TITLE: AIR CONDITIONING - AIR COOLING SYSTEM - INTRODUCE MODIFIED AIR

CONDITIONING PACK 1310A0000-03

MODIFICATION No.: 31709K7523

This page transmits Revision No. 01 of Service Bulletin No. A320-21-1135.

$$\operatorname{\sc Figure}\ 1$$  Sheet 2 Wiring Installation of the Solenoid Back-up Valve 25HH and 40HH

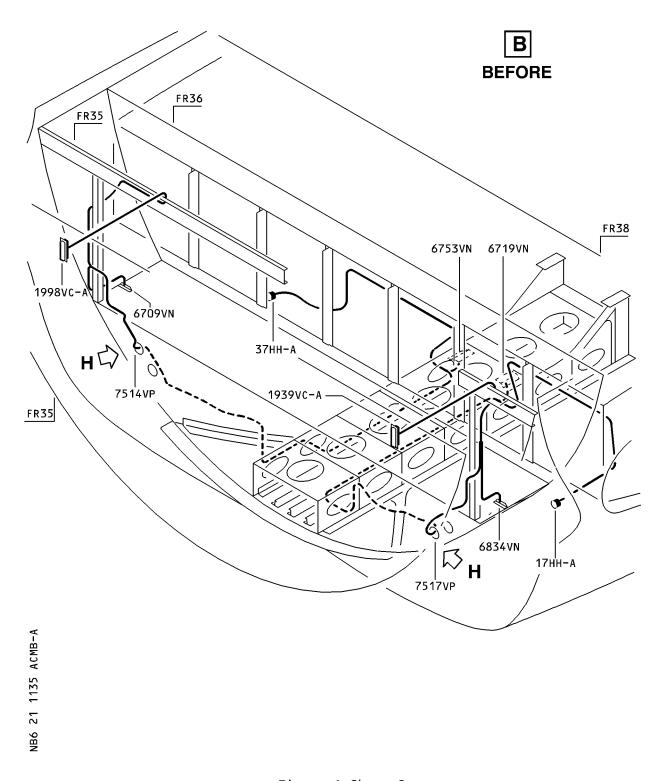
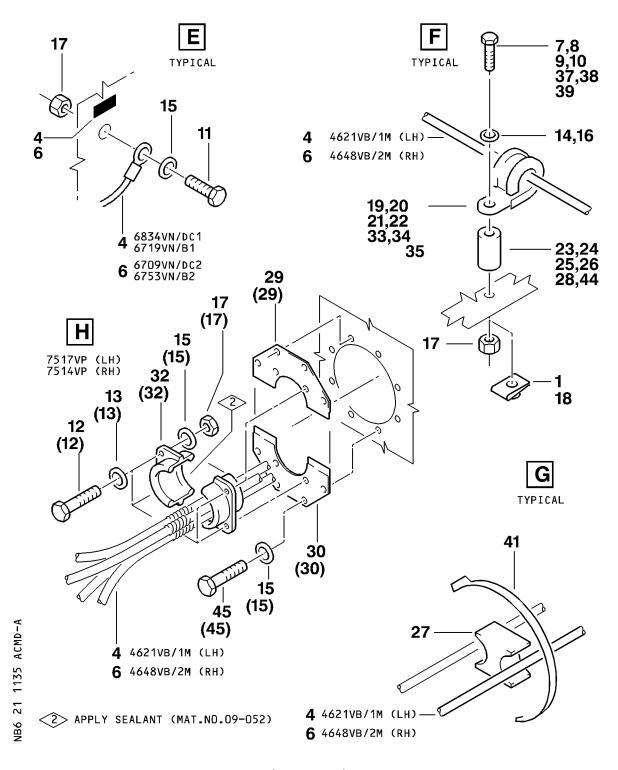
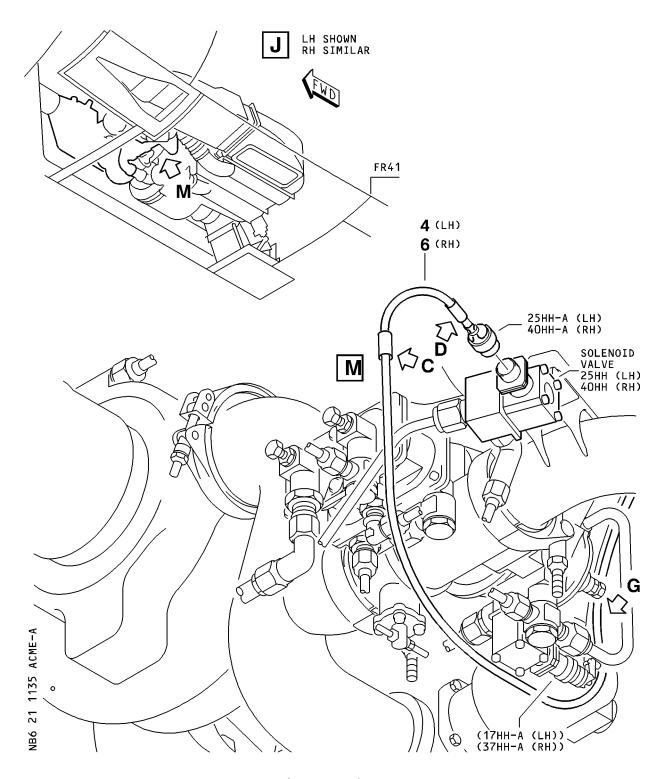
- (b) Install the new wirings 6083, 6084-R, 6084-B and 6085 to the existing cable route 4621VB as given in the Hook-up Chart figure 4
  - , line 1 thru 4 and Wiring figure 2 .

- $\underline{1}$  Remove the wire 6054-B from the plug 1939VC-A up to the FR35 (FR35/8 for A321).
- 2 At the pressure bulkhead FR35 (FR35/8 for A321) remove :

3 To the cable route 4621VB between the new solenoid back-up valve 25HH and the connector 1939VC-A install:

Figure 1 Sheet 3
Wiring Installation of the Solenoid Back-up Valve 25HH and 40HH

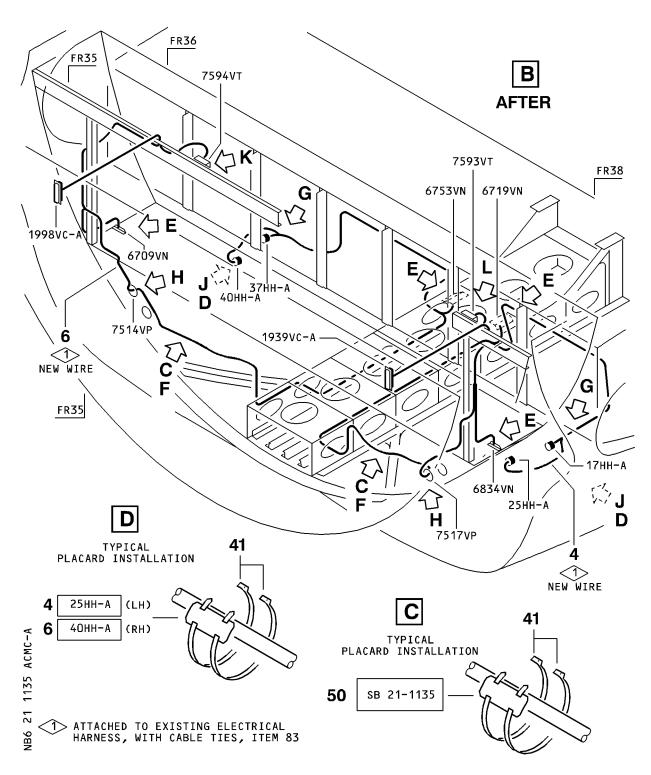
- (1) Modify the Air Conditioning Pack in accordance with the Liebherr Aerospace Service Bulletin No. 1310A-21-02.
- (2) Kit 211135D01R00
  - (a) Install the sections for the terminal blocks 7593VT and 7594VT at FR35 (Fr35/8 for 321).

1 At cross beam FR35 (FR35/8 for A321) install:

2 sections D9249174222200 Item 3

3 To the sections item 3 install:

4 nuts NAS5066-08-1 Item 1

Figure 1 Sheet 6 Wiring Installation of the Solenoid Back-up Valve 25HH and 40HH

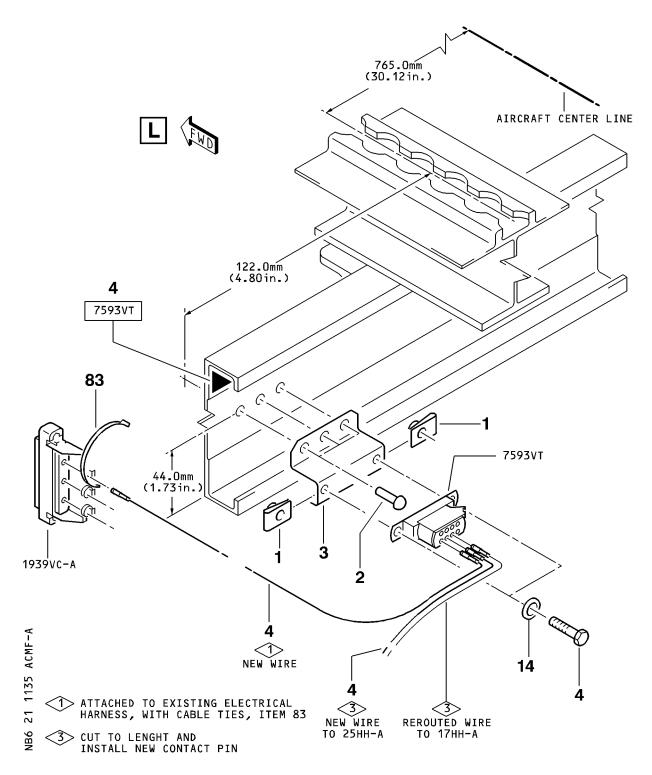
- $\underline{1}$  Cut the wire 6054-B to the correct length and install it to the terminal block 7593VT.
- (d) Install the new wirings 6187, 6188-R, 6188-B and 6189 to the cable route 4648VB as given in the Hook-up Chart figure 5
  - , line 1 thru 4 and Wiring figure 3 .

Figure 1 Sheet 7
Wiring Installation of the Solenoid Back-up Valve 25HH and 40HH

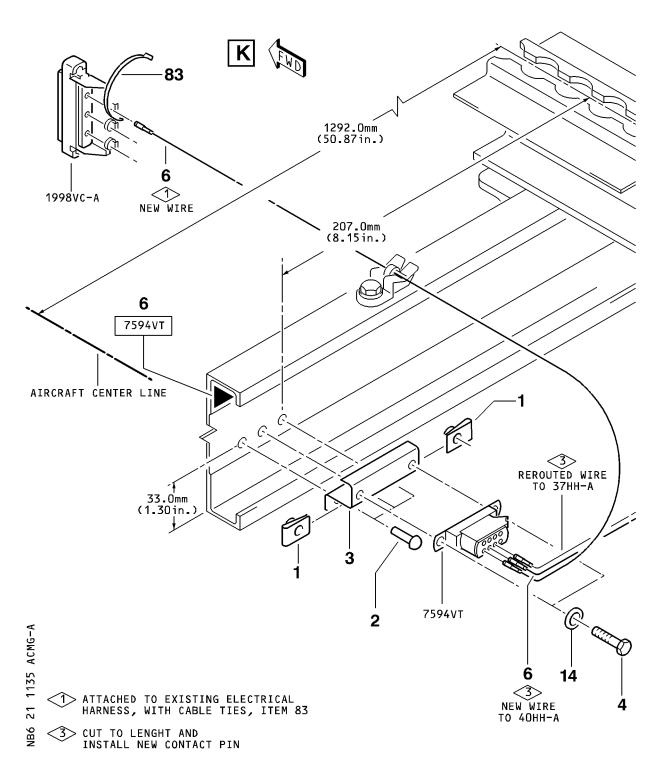
- 1 Remove the wire 6162-B from the plug 1998VC-A up to FR35 (FR35/8 for A321).
- 2 At the pressure bulkhead FR35 (FR35/8 for A321) remove :

<u>3</u> Between the new solenoid back up valve 40HH and the terminal block 7594VT install:

1 Cut the wire 6162-B to the correct length and install it to the terminal block 7594VT.
